To: Planning Committee **Date:** June 24, 2011
From: Brian J. Jackson, MCIP **File:** RZ 09-499249
 Director of Development
Re: Application by Western Dayton Homes Ltd. for Rezoning at 8540 No. 3 Road from Single Detached (RS1/E) to Medium Density Townhouses (RTM2)

Western Dayton Homes Ltd. has applied to the City of Richmond for permission to rezone 8540 No. 3 Road (**Attachment 1**) from Single Detached (RS1/E) to Medium Density Townhouses (RTM2) in order to permit the development of eight (8) 2½-storey townhouse units with vehicle access from Bowcock Road (**Attachment 2**).

RZ 09-499249

Drawing Title
**PRELIMINARY
 LANDSCAPE PLAN**

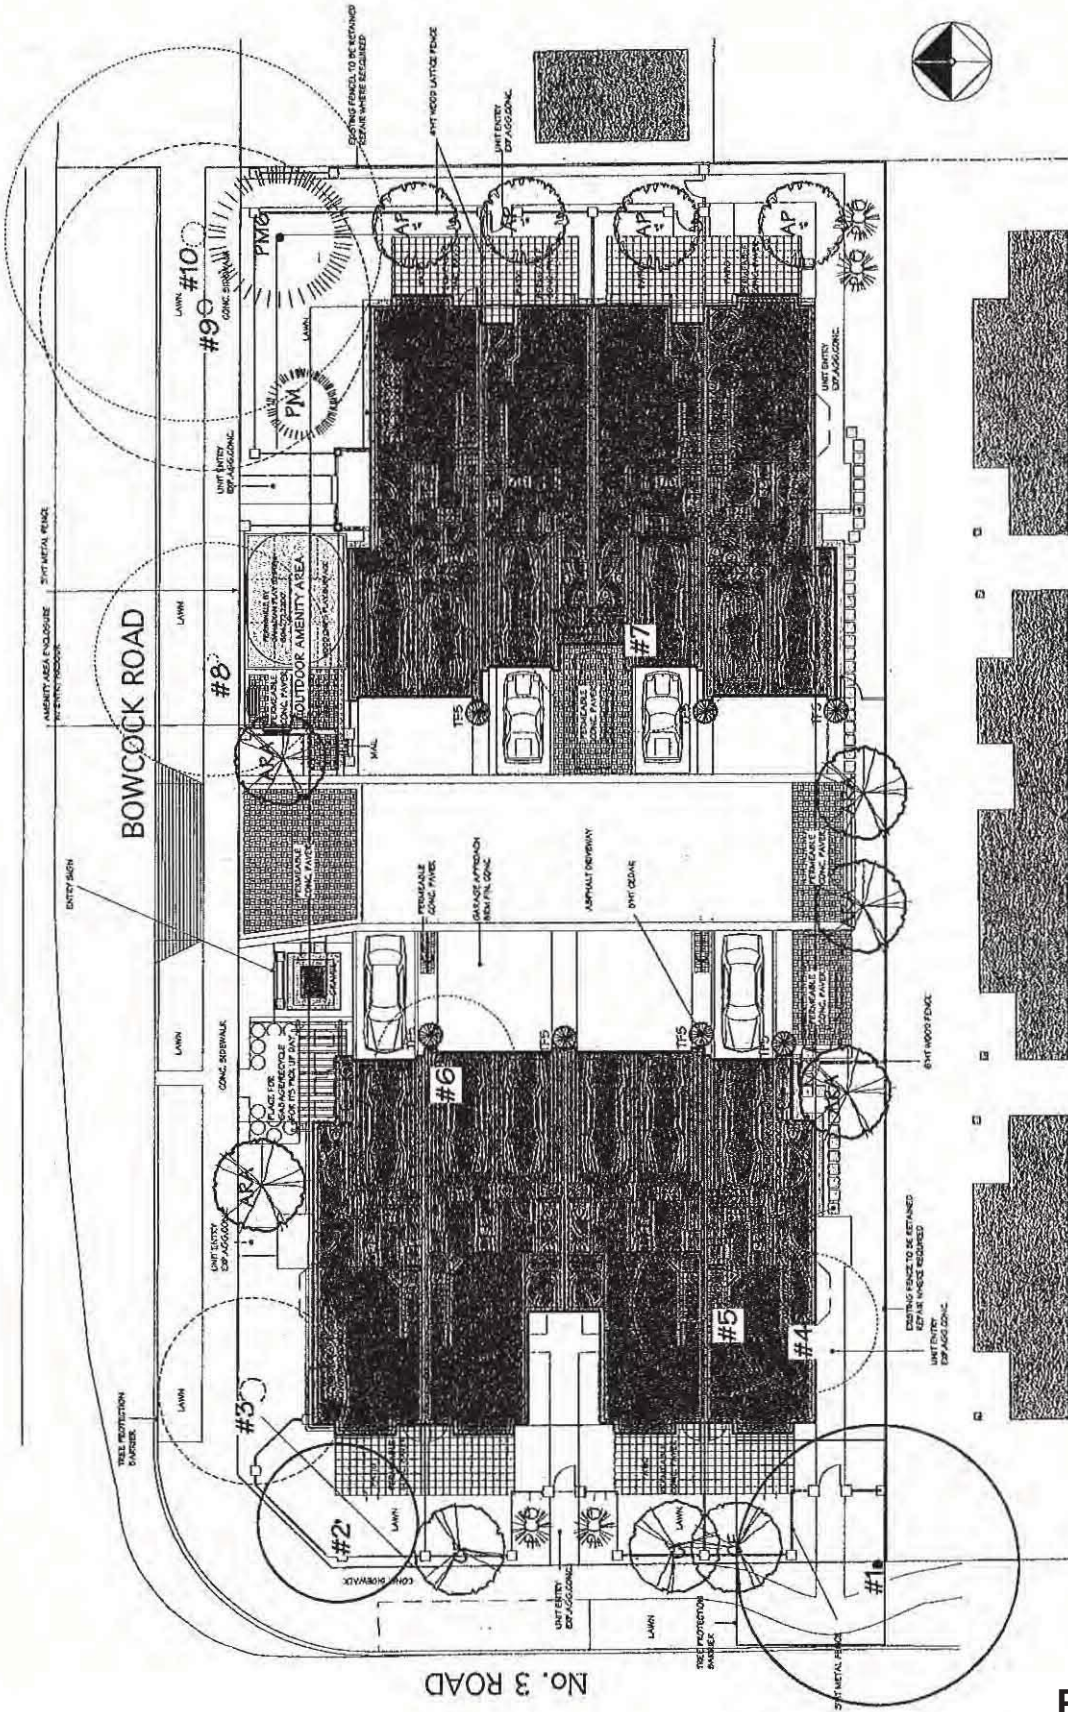
Based on the 2:1 tree replacement ratio goal stated in the Official Community Plan (OCP), 10 replacement trees are required for the removal of five (5) on-site trees. According to the Preliminary Landscape Plan (**Attachment 2**), the developer is proposing to plant 18 trees on-site. Should the applicant wish to begin site preparation work after Third Reading of the rezoning bylaw, but prior to Final Adoption of the rezoning bylaw, the applicant will be required to obtain a Tree Permit, install tree protection around trees to be retained, and submit a landscape security (i.e. \$10,000: \$500/replacement tree + \$5,000 for a larger calliper tree) to ensure the replacement planting will be provided.

Drawing Title:
**EXISTING TREE
PRESERVATION PLAN**

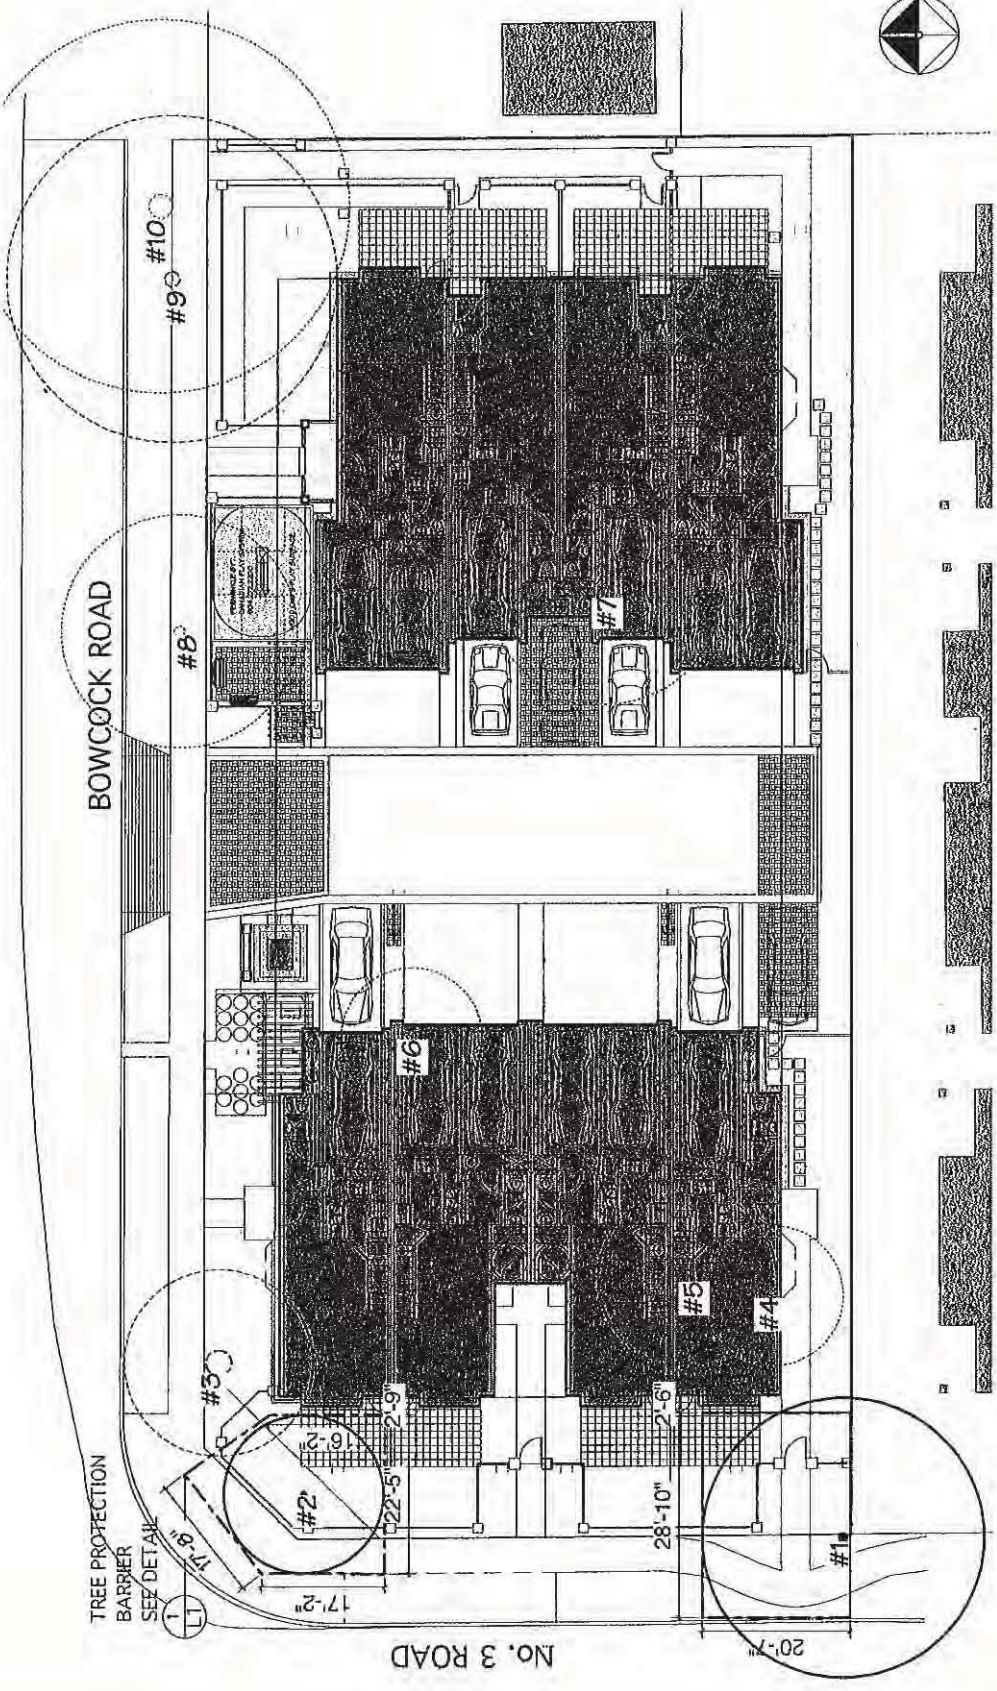
A Tree Survey and a Certified Arborist's report were submitted in support of the application. Six (6) bylaw-sized trees on-site and four (4) street trees along the site frontages were identified on the Tree Survey and reviewed by the Arborist. The City's Tree Preservation Coordinator has reviewed the Arborist Report and concurred with the Arborist's recommendations to preserve two (2) trees and remove eight (8) bylaw-sized trees (see **Attachment 4** for a Tree Preservation Plan).

The applicant has committed to the retention of one (1) bylaw-sized tree on-site and one (1) street tree located at the southwest corner of the site. In order to ensure that these trees will not be damaged during construction, as a condition of rezoning, the applicant is required to submit a \$6,000 tree survival security. The City will retain 50% of the security until the proposed landscaping is planted on-site. The City will retain the remaining 50% of the security for two (2) year after inspection of the completed landscaping to ensure that the protected trees have survived. In addition, a proof of contract with a Certified Arborist for supervision of on-site works conducted close to all protected trees will be required at the Development Permit stage.
